A428 Black Cat to Caxton Gibbet improvements

TR010044

9.93 Applicant's Comments on Deadline 6 Submissions

**The Infrastructure Planning
(Examination Procedure) Rules 2010****A428 Black Cat to Caxton Gibbet
improvements
Development Consent Order 202[]**

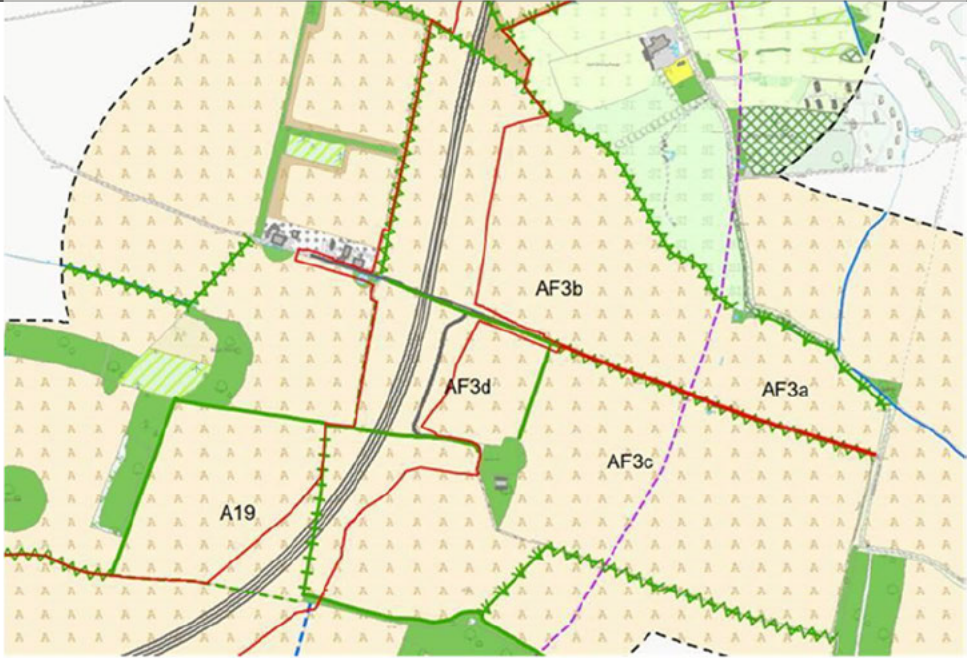
| Reference Number | Interested Parties Submission/Applicant's Comments |
|----------------------|---|
| REP6-058j | <p>Transect 12 – Static Location S5 (north-south hedge) – Table 6, Page 70</p> <p>Static Location S5 recorded moderate bat activity in July and September 2021, indicating that the north-south hedge is a key bat commuting corridor for the local bat population.</p> <p>The alignment of the proposed A428 will result in the severance of this north-south hedge. No mitigation is proposed upon sheet 11 of the Environmental Master Plan [REP4-047] to mitigate the effect on this bat commuting/foraging route.</p> <p>Given the evidence provided, the Councils consider that bat mitigation measures are required at this location to avoid adverse effects on the local bat population. The Councils seek justification from National Highways as to why a bat crossing has not been proposed at this location.</p> |

| Reference Number | Interested Parties Submission/Applicant's Comments |
|----------------------|---|
| Applicant's comments | <p>Activity transects and static detector results in 2021 confirmed similar species assemblages and numbers of passes to those found in 2018, (with relatively higher activity at Static Location 2 on Transect 9 as described in the report).</p> <p>The level of activity on this transect in 2018 did warrant further investigation at this habitat feature and therefore crossing point surveys were undertaken here in 2019, and repeated in autumn 2021 (specifically for Barbastelle). At this location (BCP7) in 2019 there was a mean of 12.8 passes per survey (each of 1 hour duration) associated with the hedge. Common Pipistrelle was the dominant species recorded, accounting for 48% of the passes, with Soprano Pipistrelle 23%, Brown Long-eared bat 17% and a lower number of passes of Noctule (2%), Barbastelle (<1%), Myotis species (<1%) and unidentified bats (5%). There was very low activity in the autumn of 2021 at BCP7 with a mean of 5.33 passes and very low activity on the static detector (a maximum of 1.8 passes per hour).</p> <p>As a comparison, the habitat features where the two main crossing point structures are proposed over the River Great Ouse (BCP1) and an east-west hedge (BCP2) linking to ancient woodland in the west to woodland to the east had a mean of 27.3 and 51.5 passes respectively per survey, significantly higher than BCP7 with 12.8 passes. BCP1 and 2 had similar species assemblages, but with higher numbers of rarer species such as Daubenton's and Barbastelle.</p> |

| Reference Number | Interested Parties Submission/Applicant's Comments |
|--|--|
| | <p>A description of the habitat features and rationale for the provision of mitigation structures is provided in Appendix C of the Barbastelle Bat Surveys and Mitigation Technical Note [TR010044/EXAM9.54v4] submitted at Deadline 8. This includes a description of two main structures over the River Great Ouse at BCP1 and a bat tunnel at BCP2, three additional crossing structures and a list of other structures that will facilitate the movement of bats, along with the legacy A428 which will remain as a strong corridor for bat movement but without the traffic numbers that it experiences at present. Bats will be able to move east-west benefiting from foraging along the Scheme. This will reduce the need for bats to cross the Scheme.</p> |
